NRL Report No. B-1993

Report of Test

Horns, Types H-3 and H-4

Schwarze Electric Company
Adrian, Michigan

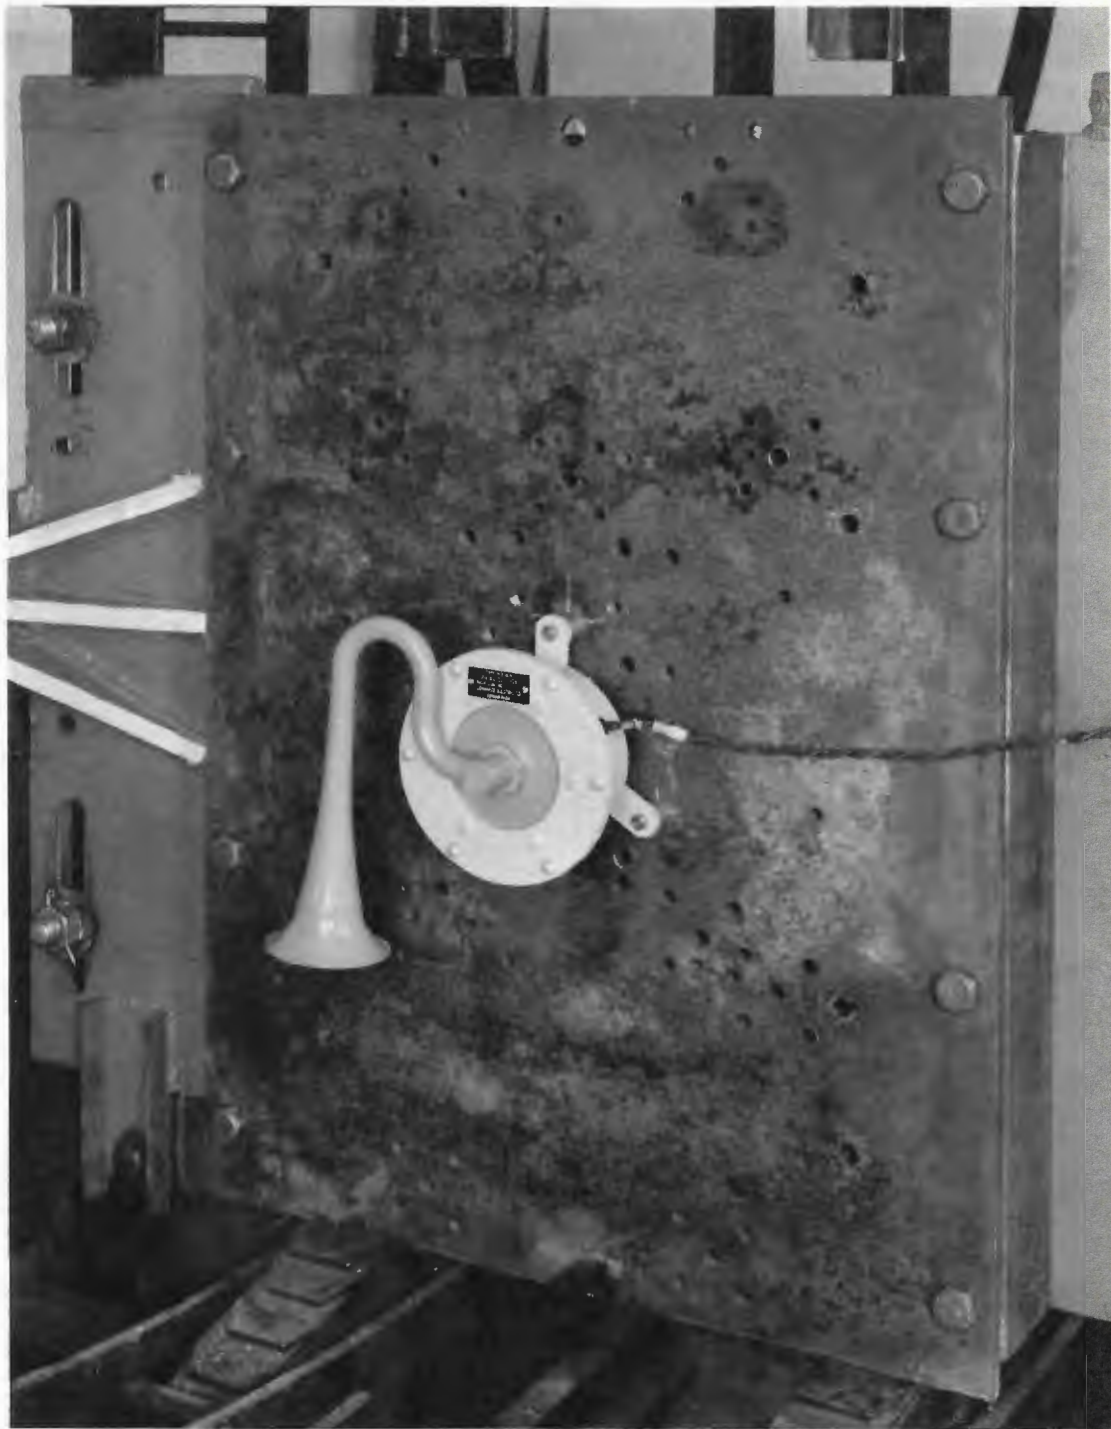
4. For additional information, the sample horns, mounted as shown in Plate 4, were subjected to the HI shock test, specified in reference (c), at the conclusion of all other tests.

On the first blow (back), the projector was broken off at its fitting. The mounting straps were loosened from the housing.

The first two blows (vertical) produced no apparent damage. On the third and fourth blows (back), the projector was loosened in the collar and the mounting straps were torn loose from the housing.

18. The results of the HI shock test indicate that the strength of the sample horns is not adequate to withstand high impact shock. It is believed that some form of resilient mounting plate would provide the desired shock integrity. It is also possible that the use of a resilient mounting plate will improve the stability of the operation of the H-3 horn. Laboratory experience indicates that this type is sensitive to the flexibility of its mounting.
